TECHNICAL NOTES SERIES

JOWETT JAVELIN – PA, PB, PC, PD & PE

JOWETT JUPITER – SA & SC

PART III – SERVICE BULLETINS – JAVELIN AND JUPITER

Above: Figure 2. Modifying early front timing cover, camshaft and Section 'AA'.

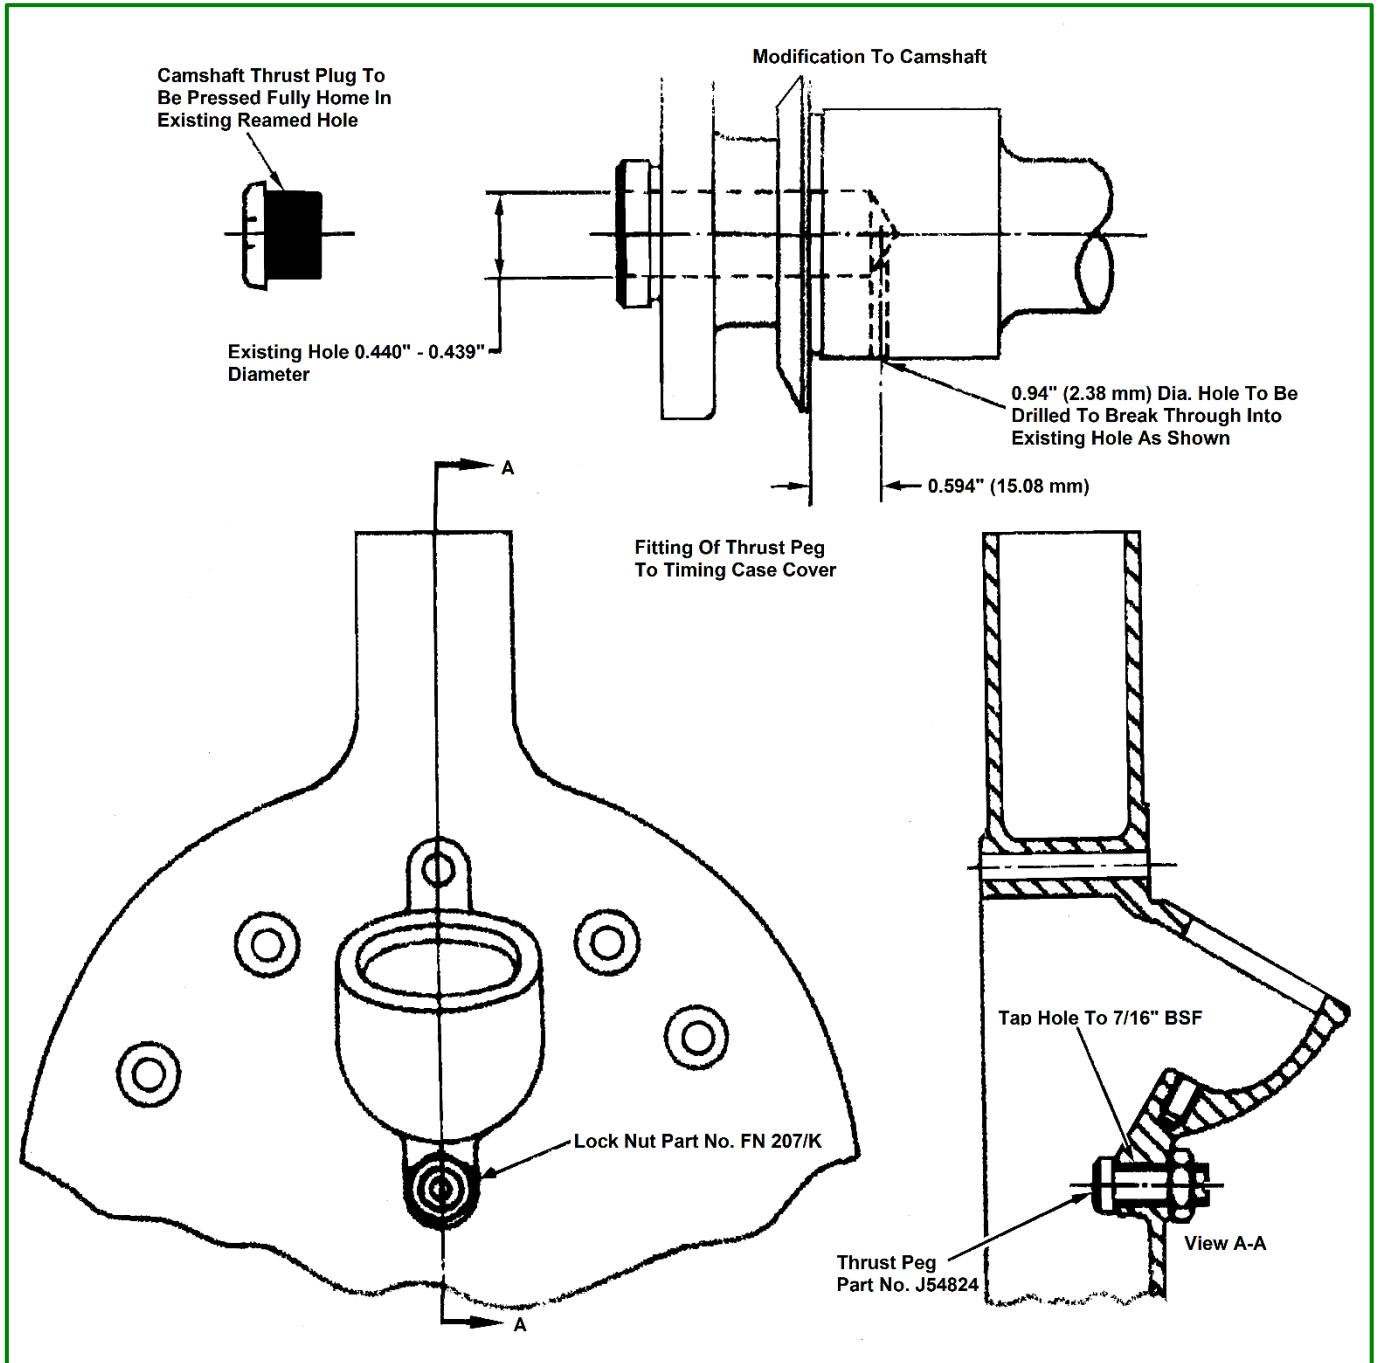
E2 PE 23805, E2 PE 23811, E2 PE 23813, E2 PE 23816, E2 PE 23817, E2 PE 23829, E2 PE 23837, E2 PE 23842 and E2 PE 23825, a modified timing case cover, camshaft and thrust peg assembly has been introduced in order to regulate camshaft end float, see *Figure 1*. The front timing case cover has been modified to incorporate a threaded thrust peg, which is locked in position by a locknut.

Figure 1. Modification to reverse selector lock lever.

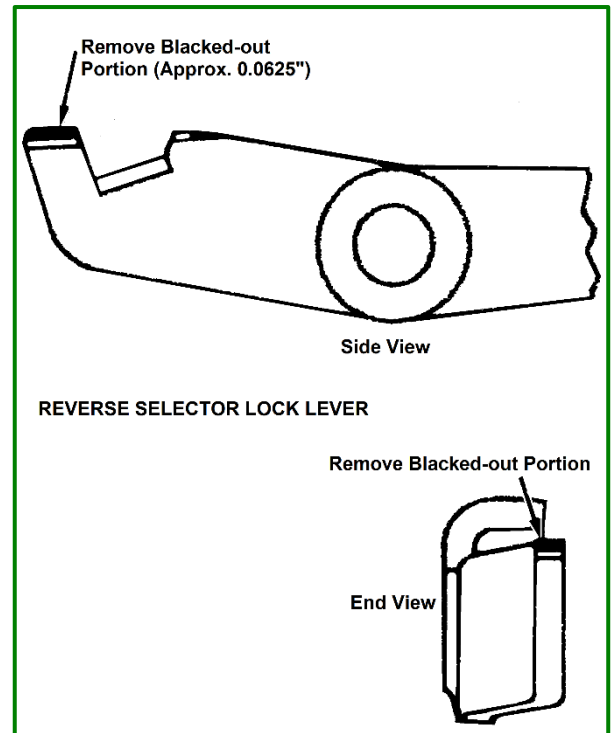
To eliminate this fault remove approximately $\frac{1}{16}$ -in. (1.6 mm) from the reverse selector lock lever and back off as shown in *Figure 1*.

Right: Figure 1. Arrangement of modified horn pick up brush.

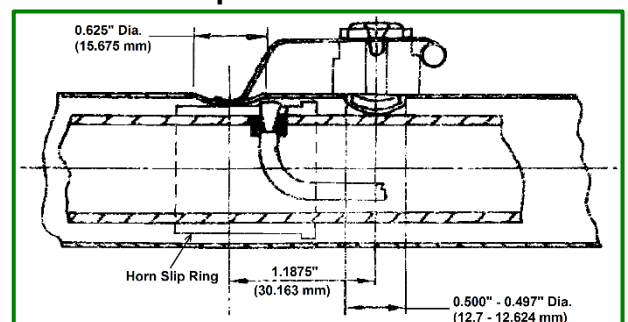
The horn pick up brush has been modified to the design shown in *Figure 1*.

The existing steering column can be modified to incorporate the latest horn brush by drilling the additional hole shown in *Figure 1*, and fitting the new pick up brush assembly, Part Number J54733/A, and using the existing clip.

Figure 1, Featuring details 'A', 'B' and 'C'. Front spring arm conversion (RHS shown).

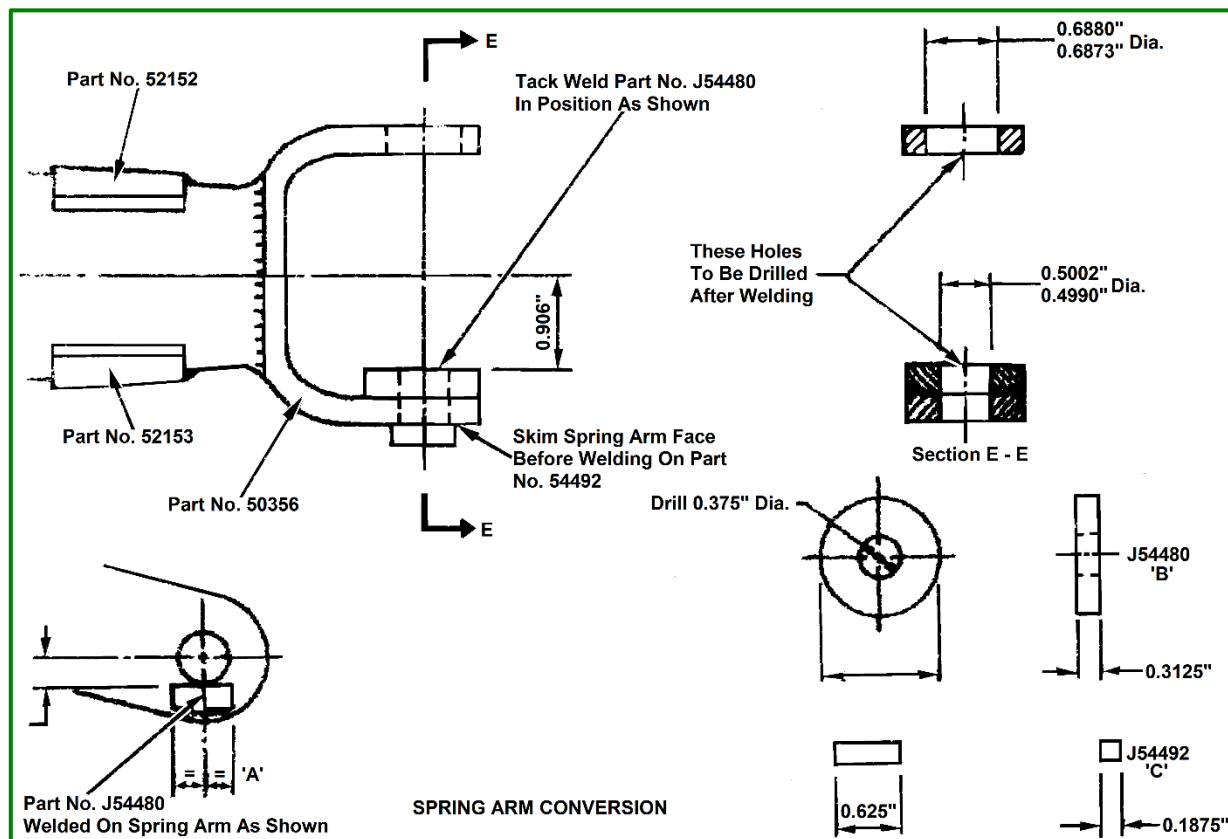
Reference should be made to *Figures 1 'A', 'B' and 'C'* for conversion instructions. *Figure 1 'A'* shows the general arrangement, *Figure 1 'B'* and *Figure 1 'C'* show the parts required to convert the spring arm.

Figure 2. Showing where material can be milled from cylinder head.

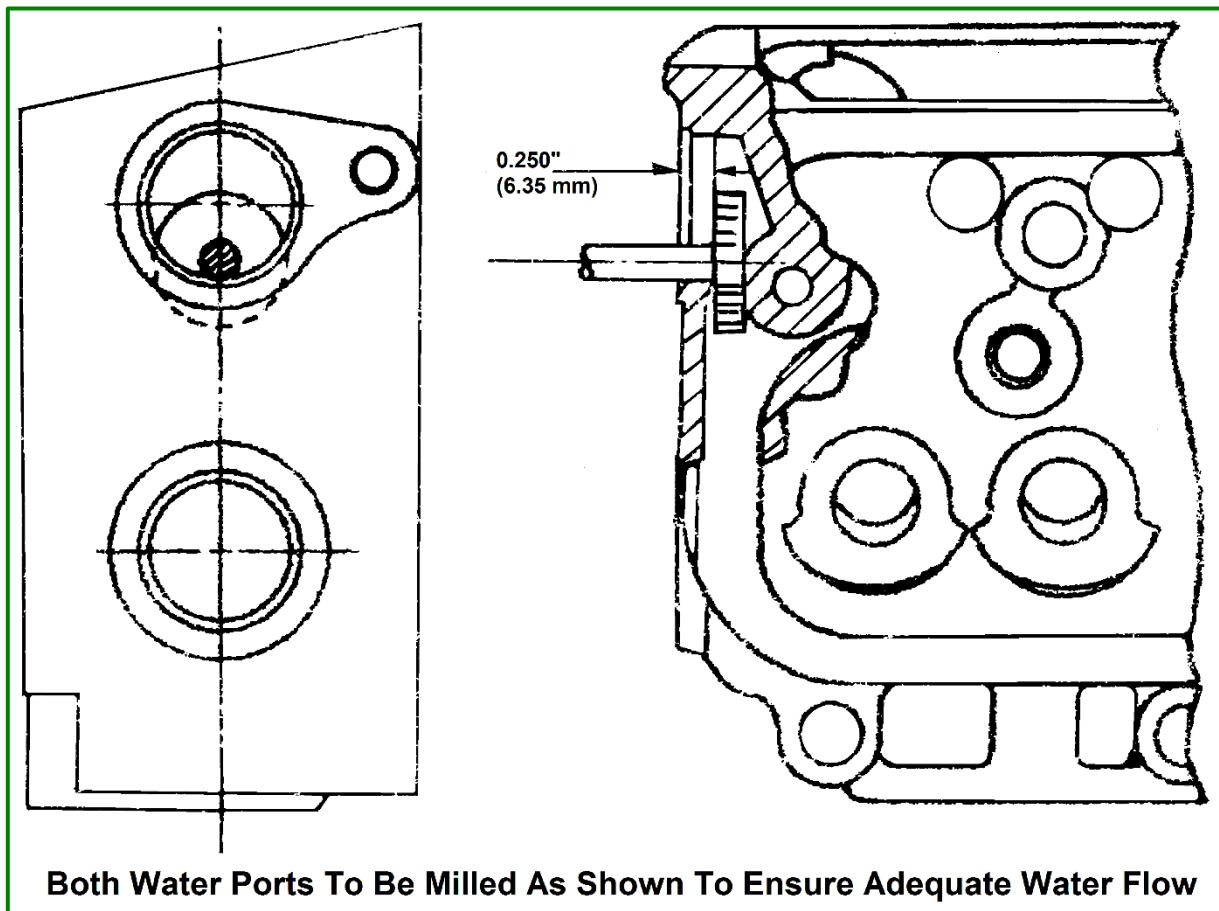
Cases have occurred where engine overheating and pinking has been caused by a restriction between the outer wall of the cylinder head and the cylinder head stud hole casting shown in *Figure 2*.

In cases of this nature an adequate water flow between these two points can be ensured by inserting a Woodruff cutter as shown in *Figure 2* through the cylinder head water port, *Figure 1*, and milling a $\frac{1}{4}$ " (6.35 mm) passage between the cylinder head outer wall and the stud hole casting.

Arrangement of roller bearing conversion.

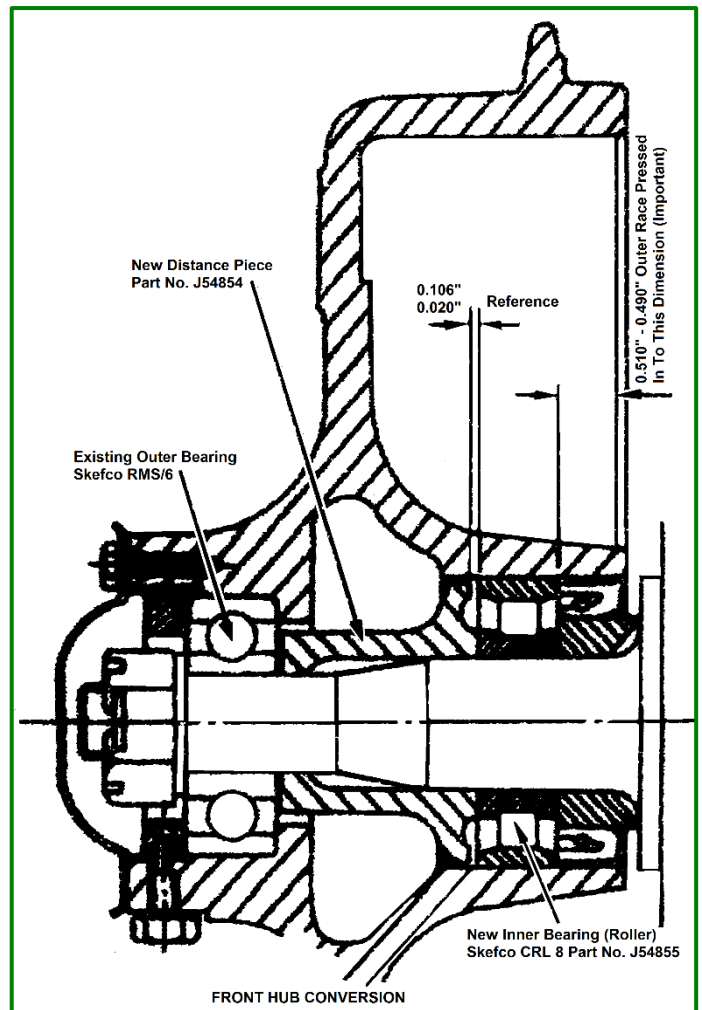
This scheme involves the changing of the inner bearing, which is of the ball type, to a roller bearing, Part Number J54855 (Skefco CRL 8), and also the distance piece to the new type, Part Number J54854. When fitting the new bearing, attention must be paid to the dimensions required when pressing the roller bearing into position, refer to *Figure 1*. The outer ball bearing, Skefco RMS/6, remains unchanged.

The roller type bearings and distance piece can be fitted to all hubs after Engine Number E0 PB 10594 (Javelin) and Engine Number E0 SA 56 (Jupiter), the new type distance piece must be used.
